Access Compliance Report Public Rights-of-Way (Pedestrian Signals)

Main Street: **BRADBURY_RD** Cross Street: **LOS_ALAMITOS_BVD** Location: **NW**

ADA ID: **SGRK211221112517** Signal Type: **One Push Button-Non APS** Overall Compliance: **No** Severity Scores: **BTN 1: 35** **BTN 2: N/A** **No BTN: N/A**

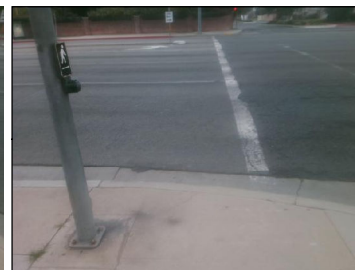
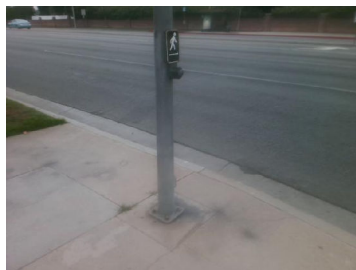
OC Std/PROW: MUTCD 4e.08, R404.2, R404.3

Possible Solutions: Replace Signal Push Button With APS Button. Remove & Relocate Sign.
